### HISTORIC PRESERVATION COMMISSION STAFF REPORT

Address:	9815 Hollow Glen Place	Meeting Date:	5/8/02
Applicant:	Philip C & Lynn C. Metzger	Report Date:	5/01/02
Resource:	Forest Glen Historic District	Public Notice:	4/24/02
Review:	HAWP	Tax Credit:	N/A
Project Num	ber: 31/8-02A	Staff:	Robin D. Ziek

**PROPOSAL:** Front porch steps and landing; alteration of kitchen window

# METZGER RESIDENCE 9815 HOLLOW GLEN PL. KENSINGTON, MD

## KITCHEN: Existing and Proposed (partial) Plan and Elevations

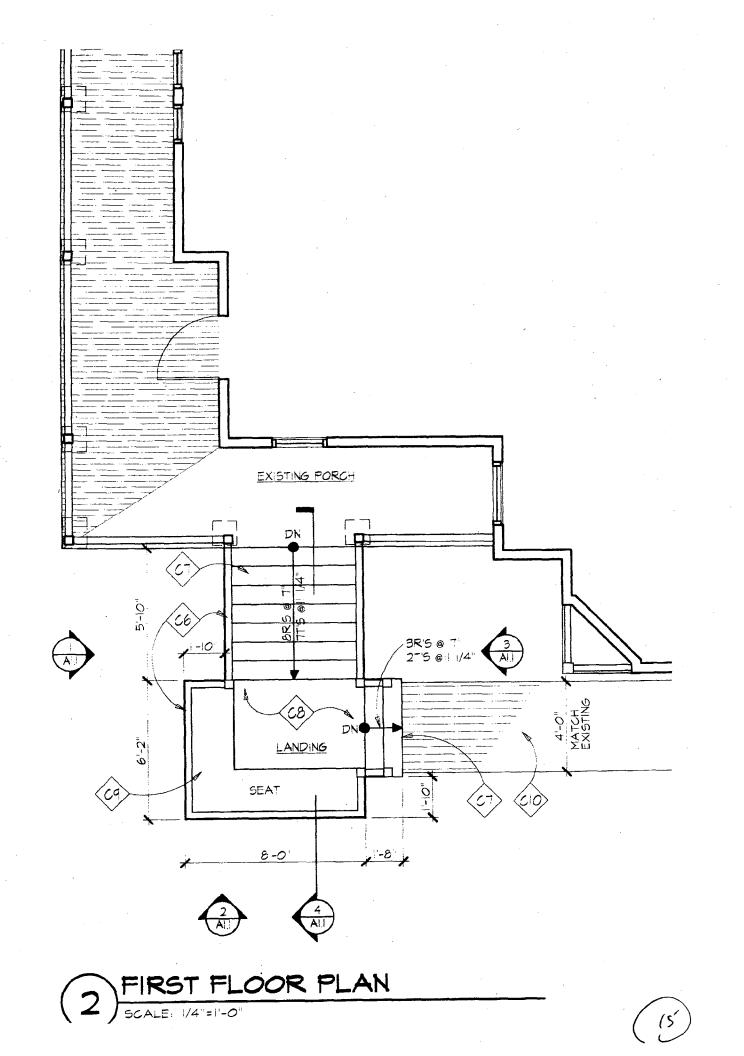
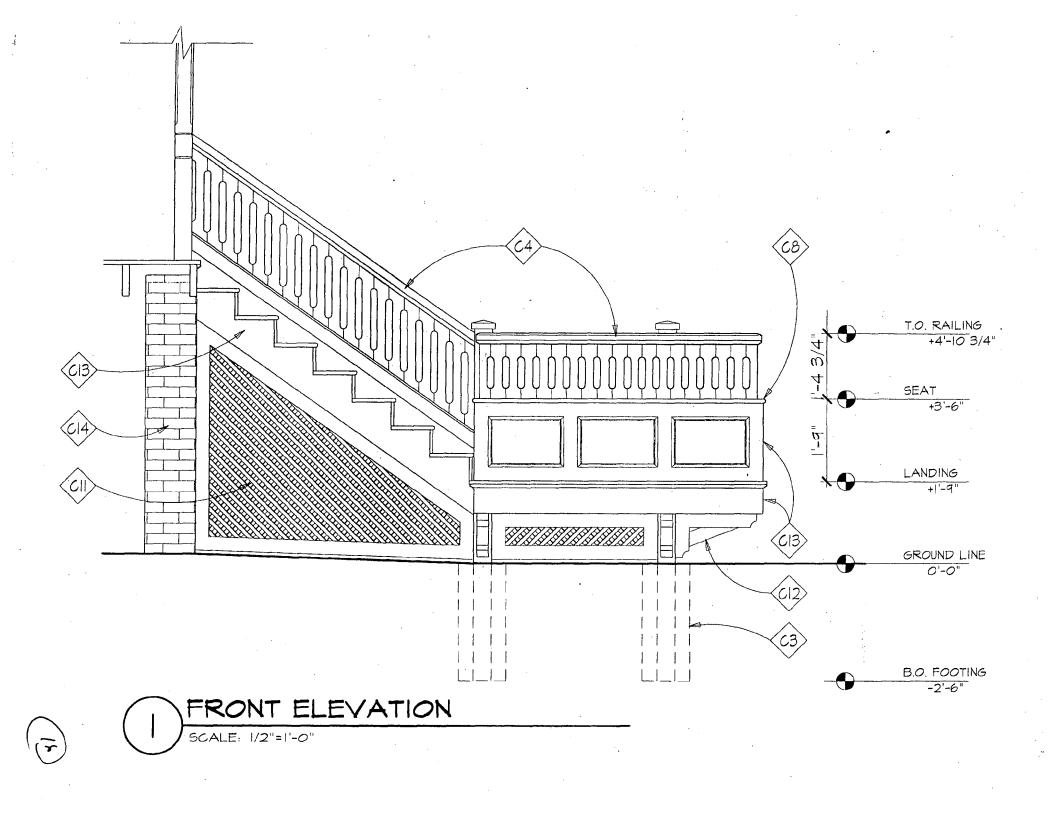
- 1. The original rear window will be retained in situ, including the original trim.
- 2. The new windows will be installed to form a grouping of three windows at the rear, with the original window in the middle, and with flat trim to distinguish the old from the new.

There are concerns with the proposed replacement of the rear kitchen window and its replacement with three new windows. Staff notes that there are other ways to achieve the goal of a bright interior with lovely views to the exterior, while retaining the original fabric. Staff recommends that the original window and trim be retained, and that two new windows could be installed to either side. The windows could be the same size as the original window, but staff would recommend that the top trim for the new windows be flat, without the cresting backband piece. The group will perform as a unit of glazing, while still allowing the original design decision with its associated original material to read clearly. This complies with Secretary of the Interior Standards #2, 3, 5, 6, 9, 10 (see Circle 21).

- 1. The original rear window will be retained in situ, including the original trim.
- 2. The new windows will be installed to form a grouping of three windows at the rear, with the original window in the middle, and with flat trim to distinguish the old from the new.
